IMPORTANT RECALL NOTICE

INFORMATION BULLETIN NO. 62

SUBJ: RECALL PROGRAM FOR THE NULL 1200-A AND 1200-2 HEADLIGHT/METER ASSEMBLIES

SHEET NO.
EM-56

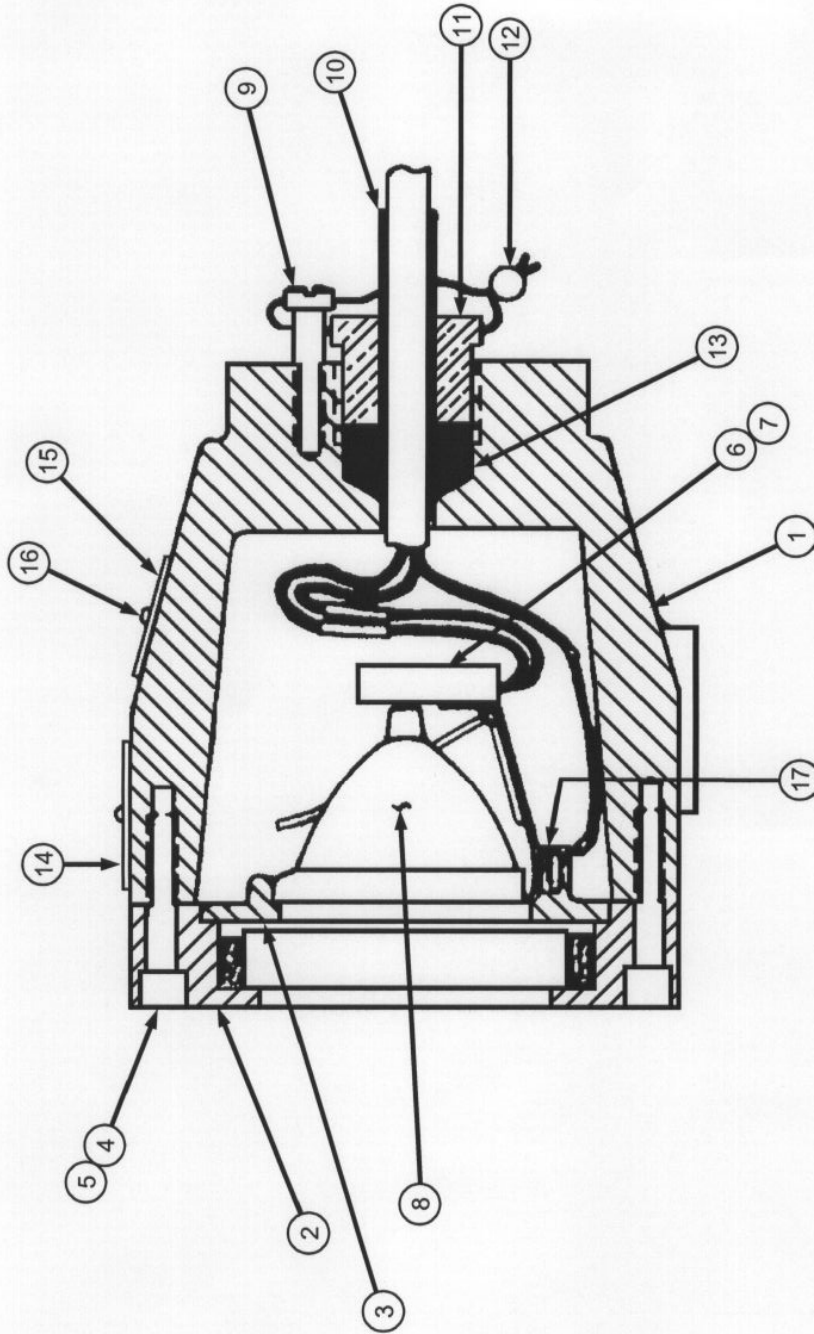
J. H. Fletcher & Co. has been informed that Null's Machine & Manufacturing Inc. is performing a recall of its headlight/ meter assemblies. J. H. Fletcher has been utilizing this component on roof bolters and MRS units since 1990, and our records indicate that we have used 379. Our part number is 34803, and the component drawing EM-56 is enclosed. If this component was installed on your equipment, there should be a copy of this headlight assembly in your serial number specific parts book, which will enable you to determine if your equipment is affected.

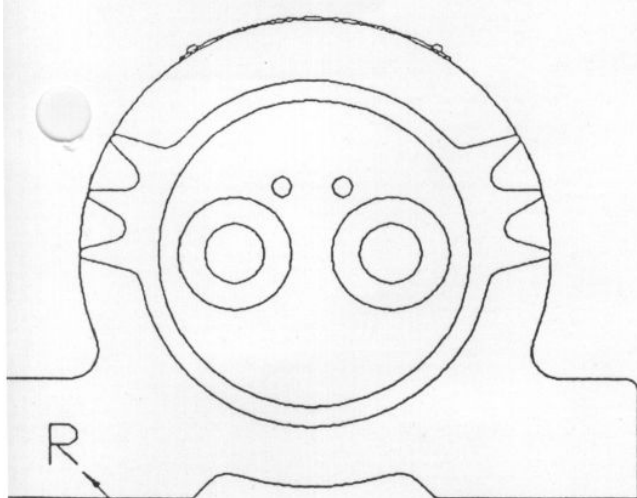
"This is a potential discrepancy notice on the model 1200-1 AL and the 1200-2 AL headlight/meter assemblies. The potential discrepancy is the flame path surface on the housing (see attached drawing). This flame path surface must be at least .500" wide to conform to MSHA standards. A flame path under the required .500" could fail to prevent the transmission of a flame resulting in a mine explosion.

Please check the flame path distance as shown in the attached drawing immediately. Use the provided inspection form to record the results of your inspection.

All assemblies that conform to MSHA standards are to be stamped using a letter "R" that is at least 1/4" high. The stamp will be placed on the mounting foot of the assembly as shown on the attached drawing. Please be advised that upon completion of the recall program any 1200 headlight/meter assembly that does not have the "R" stamp will be considered out of compliance by the MSHA inspectors."

"R" TO BE STAMPED HERE ON ALL
ASSEMBLIES THAT PASSED INSPECTION

NOTE: Stamp a minimum 1/4" high letter "R" on the foot of the assembly as shown in the attached drawing.
